DESCRIPTION:
AXLE TRSN NB 5500# 73.75"FC
AIR TIGHT

PART #:
300-034733

ECN:
897

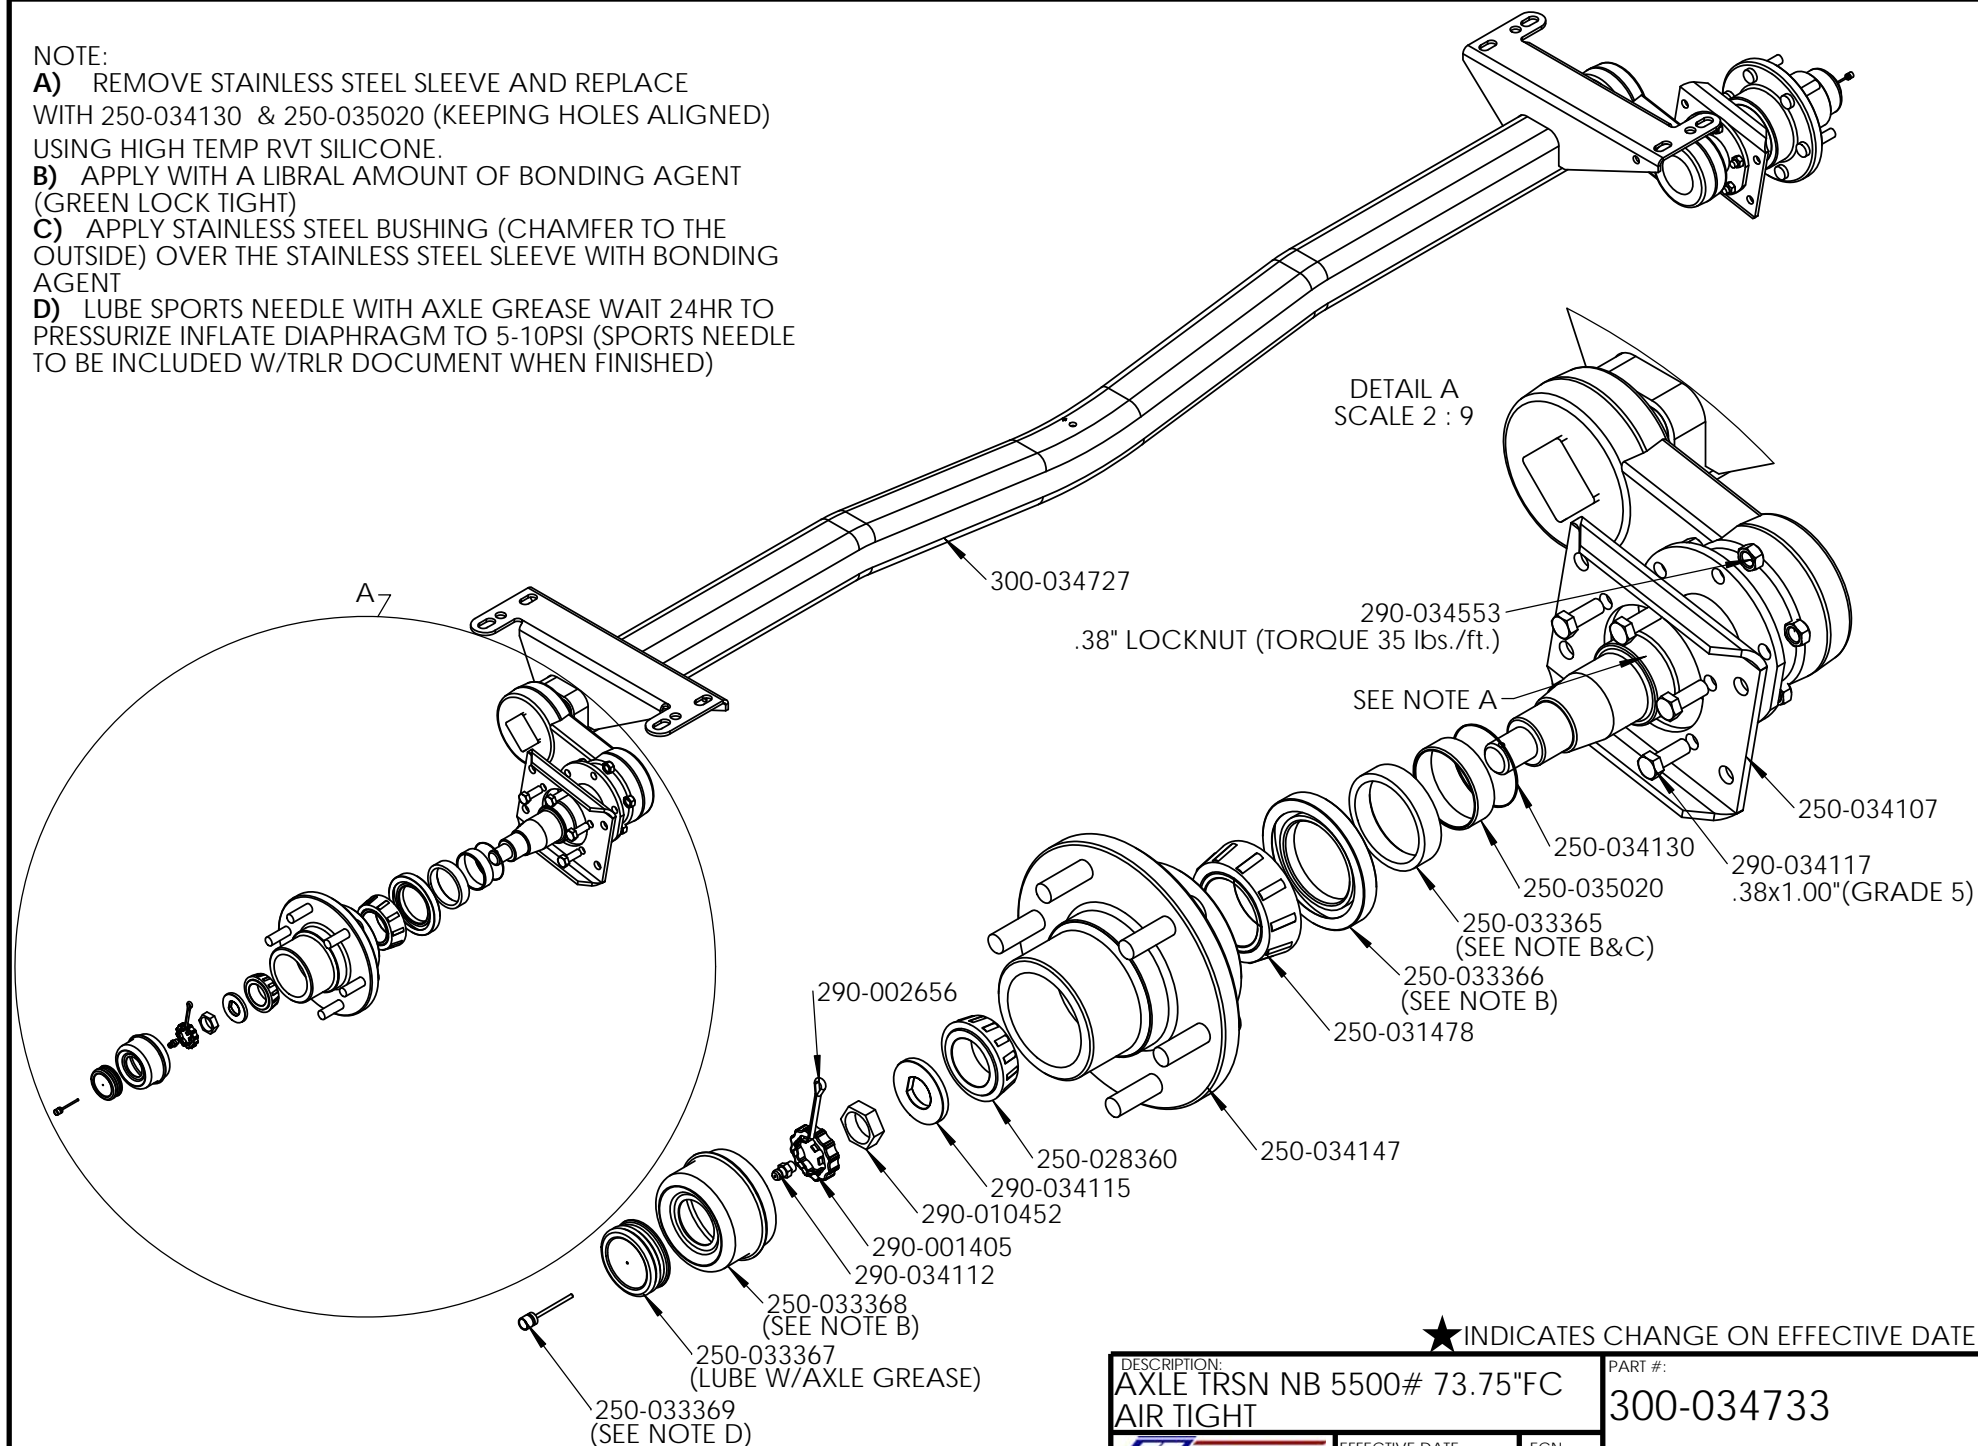
- A) REMOVE STAINLESS STEEL SLEEVE AND REPLACE WITH 250-034130 & 250-035020 (KEEPING HOLES ALIGNED) USING HIGH TEMP RVT SILICONE.
- B) APPLY WITH A LIBRAL AMOUNT OF BONDING AGENT (GREEN LOCK TIGHT)
- C) APPLY STAINLESS STEEL BUSHING (CHAMFER TO THE OUTSIDE) OVER THE STAINLESS STEEL SLEEVE WITH BONDING AGENT
- D) LUBE SPORTS NEEDLE WITH AXLE GREASE WAIT 24HR TO PRESSURIZE INFLATE DIAPHRAGM TO 5-10PSI (SPORTS NEEDLE TO BE INCLUDED W/TRLR DOCUMENT WHEN FINISHED)
